THIS ELECTRICAL DETAIL IS FOR THE SIGNAL DESIGN: 03-0369T3 DESIGNED: February 2018 SEALED: 11/04/2020 REVISED: N/A

Electrical Detail - Sheet 2 of 8 Signal Upgrade

Temporary Design 3 ELECTRICAL AND PROGRAMMING

US 17 (Market Street) at SR 1363 (Bayshore Drive)/ SR 2717 (Torchwood Boulevard)

Sig. 6

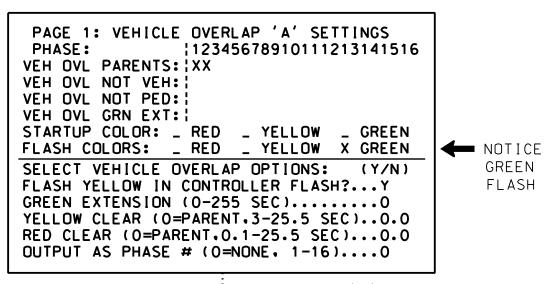
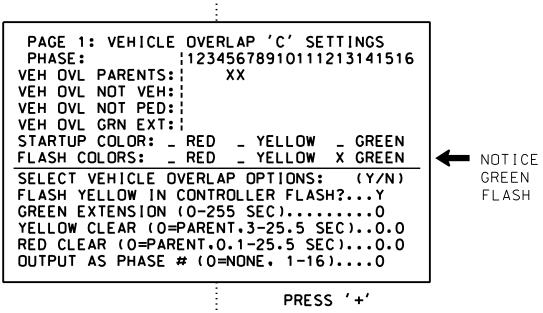
phase 3 protected dual left. Corrected

loop 1A/5A delay to 10 sec.

PREPARED BY: A.H. Thornburg REVIEWED BY: N.R. Simmons Removed phase 3 4-section FYA. Added
